CHANGE ORDER

Project Name: **Haverhill Consentino Middle School** CO No. **15**

See attached list of 4 item(s) for a total of **\$620,495.25**

Subject: **Synthetic Lawn Details**

JD-
108

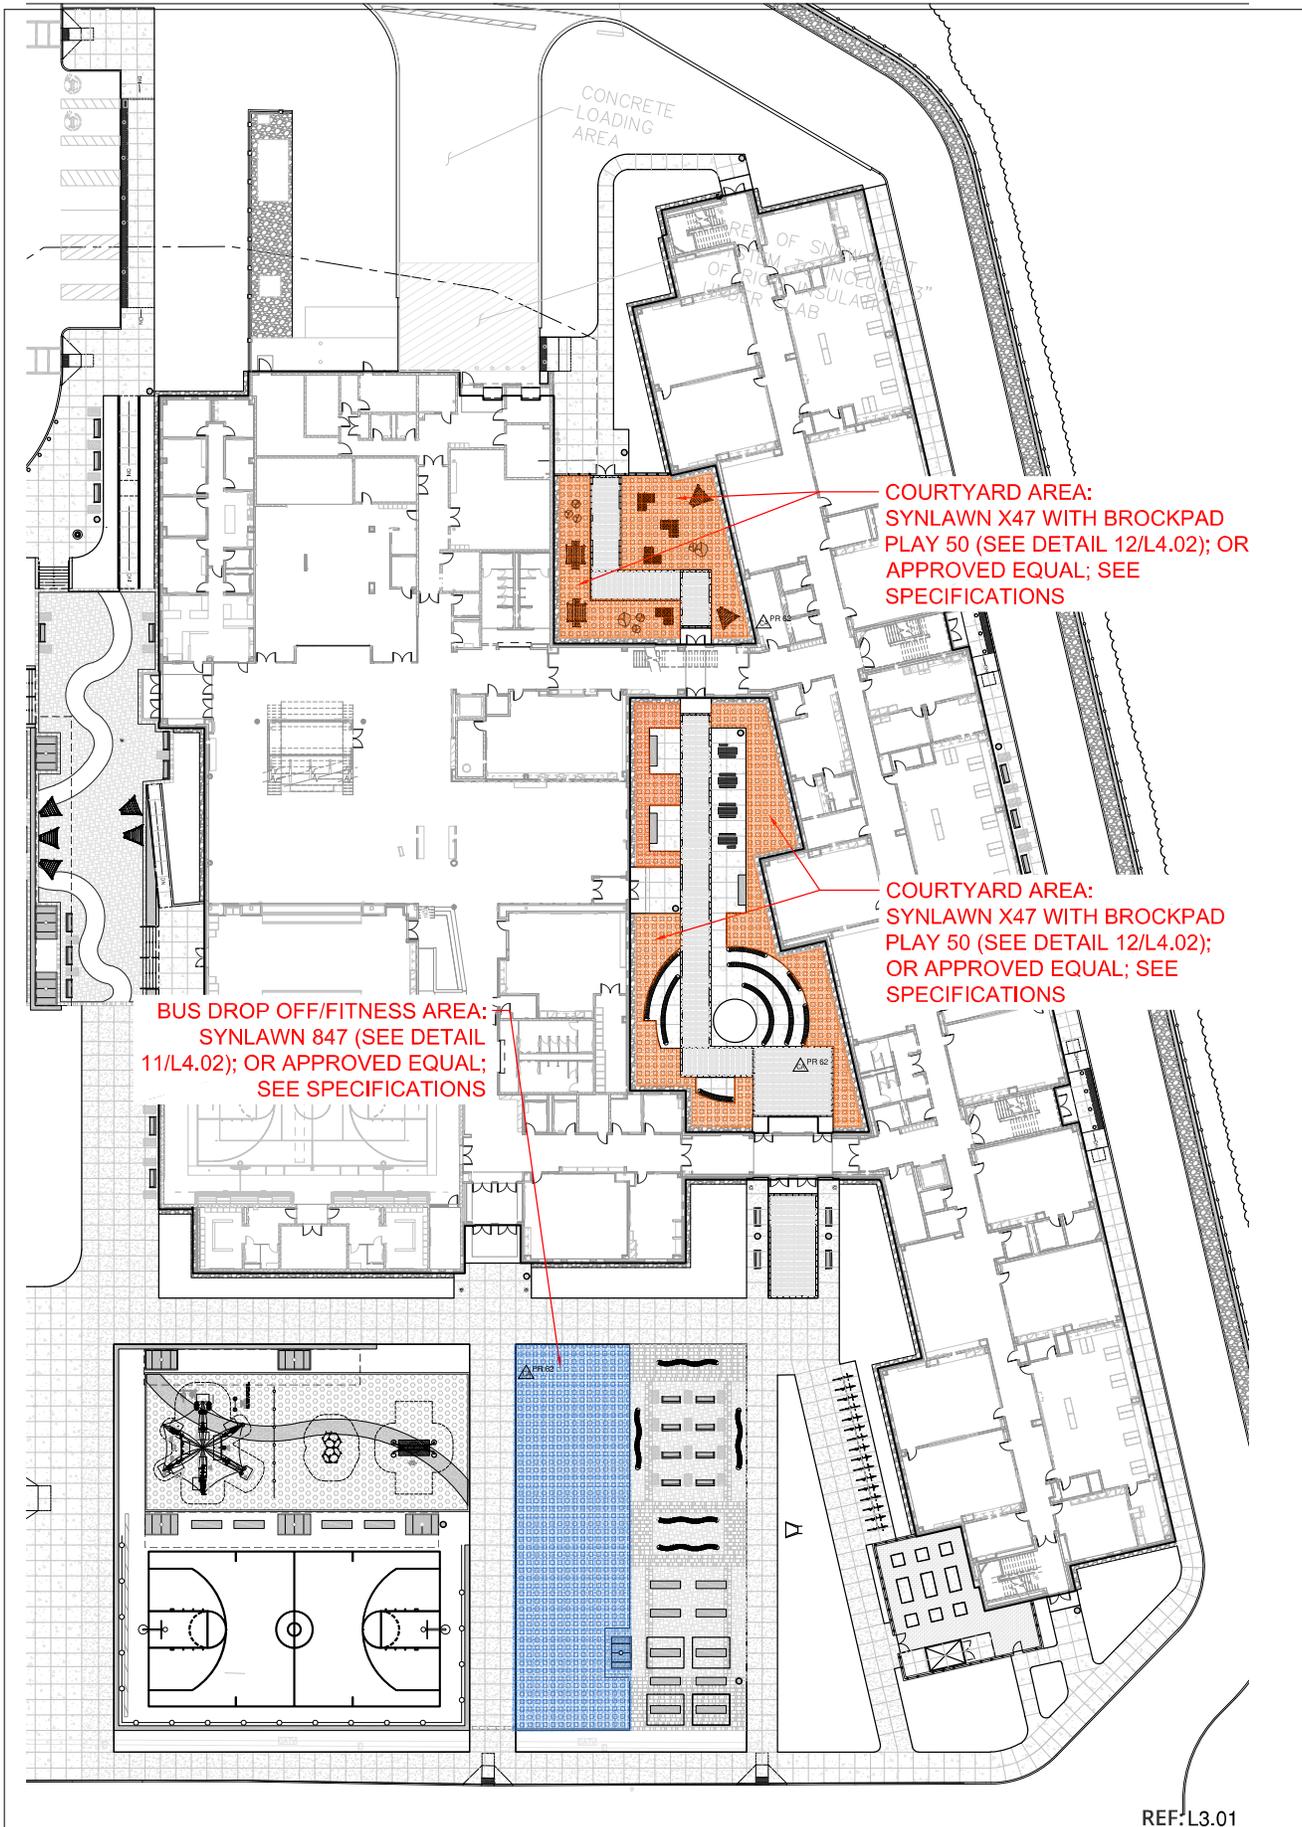
At Sheet L3.01, Planting – entry and courtyards, revise plan as shown on attached sketch **JD-108**.

BUS DROP OFF/FITNESS AREA:
SYNLAWN 847 (SEE DETAIL
11/L4.02); OR APPROVED EQUAL;
SEE SPECIFICATIONS

COURTYARD AREA:
SYNLAWN X47 WITH BROCKPAD
PLAY 50 (SEE DETAIL 12/L4.02); OR
APPROVED EQUAL; SEE
SPECIFICATIONS

DETAILS - SITE PAVING AND CURBS
L4.02

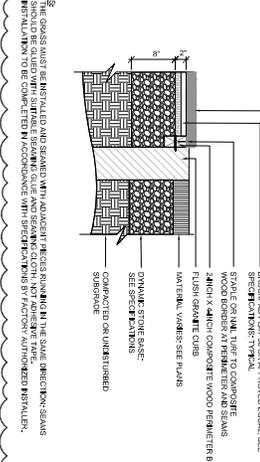
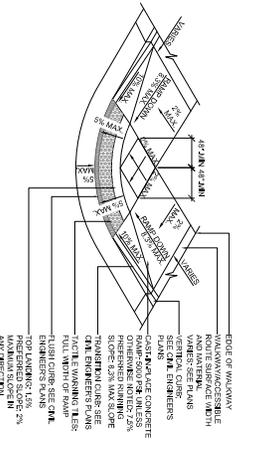
At Sheet L4.02, Details – Site Paving and Curbs, revise detail 11 and 12 as shown on attached sheet.
